File: AR 15-22

TO: Architectural Review and Historic Preservation Board

RE: Ceres Professional Plaza, 3041 Ceres Avenue, APN 015-030-029

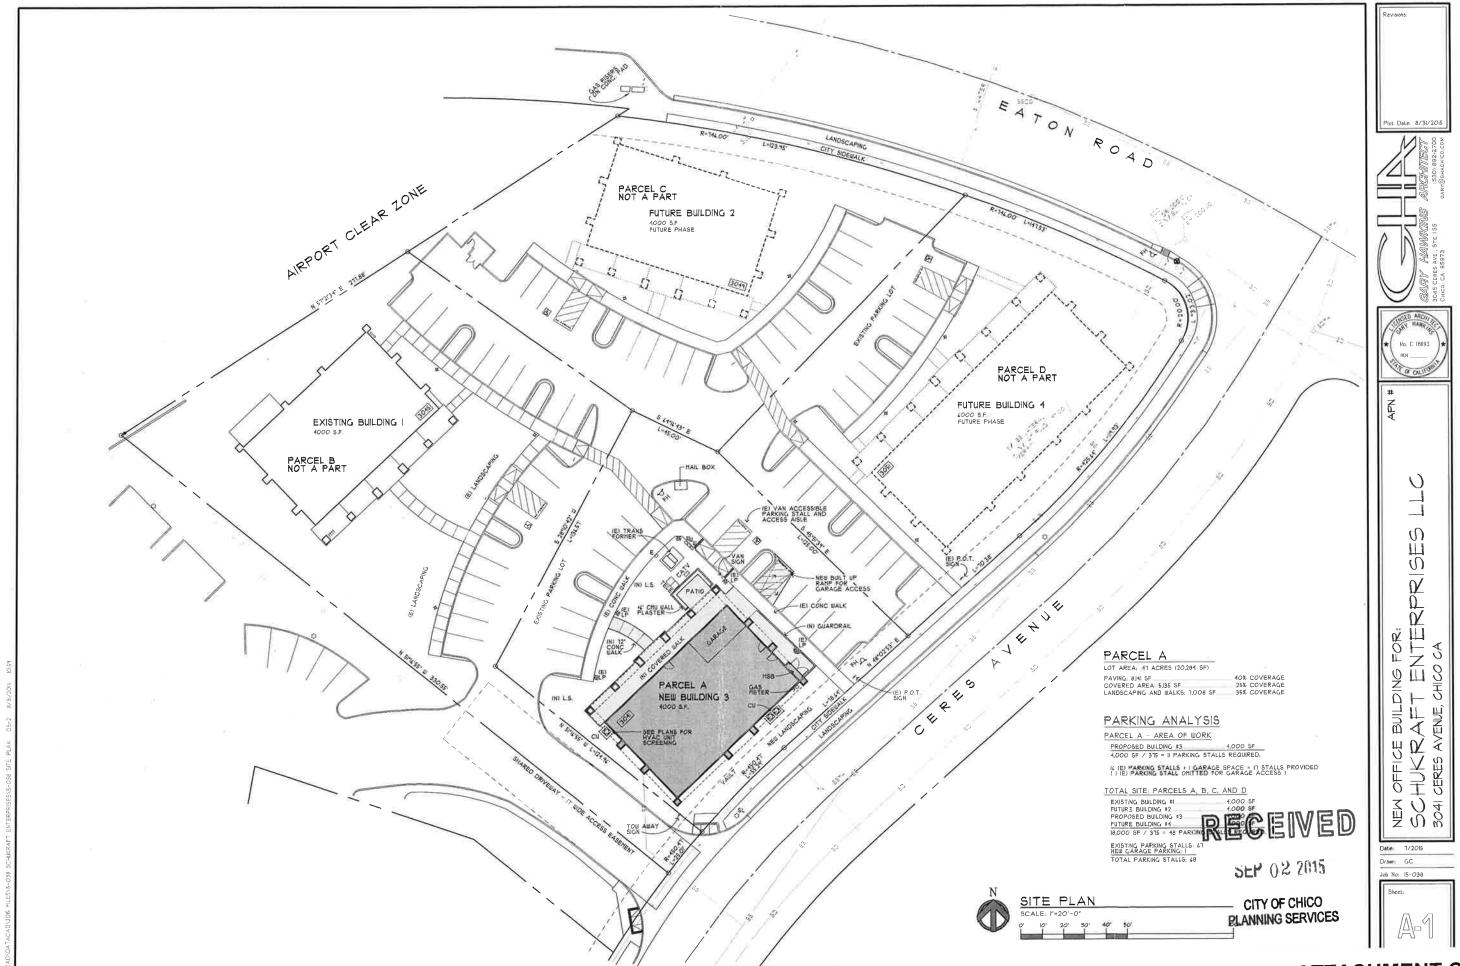
The HVAC systems are placed in two locations along the southern and western elevations. Both the site plan and landscape plan indicate that a screen will be installed around the systems, yet the specific design or detail of the screen is unknown. Staff request that the board discuss with the applicant the materials that will be utilized.

The project has a front entry alcove, approximately 10 feet wide that will connect to the front patio area. The plans provided by the applicant do not indicate if the alcove area will contain lighting. Staff recommends discussing the possibility of lighting the area with the applicant and condition accordingly.

6. All ground-mounted HVAC units shall be structurally screened as approved by the ARHPB

ATTACHMENT E

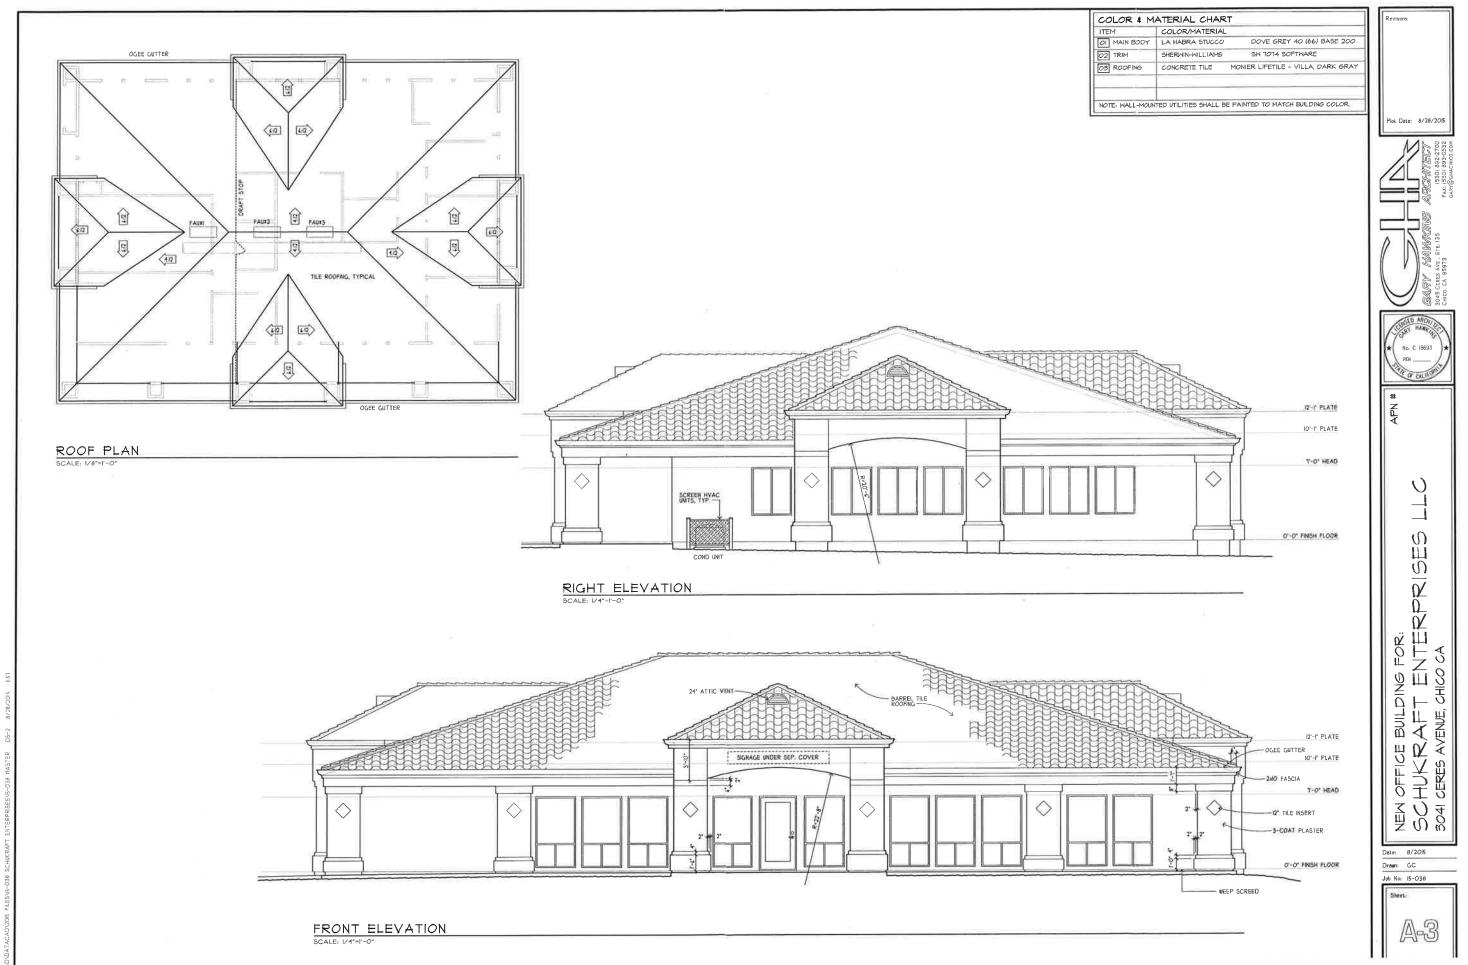
As of July 1, 2015 the City of Chico is responsible for implementing Low Impact Development (LID) requirements as part of the State Water Resource Control Board's MS4 General Permit. Because of this new requirement, staff recommends a condition of approval that will allow flexibility in the final landscape plan to ensure the project will be in conformance with LID standards.

- 3. All parapet caps and other metal flashing shall be painted, consistent with the approved building colors.
- 4. The proposed landscape plan may be modified to meet LID requirements.
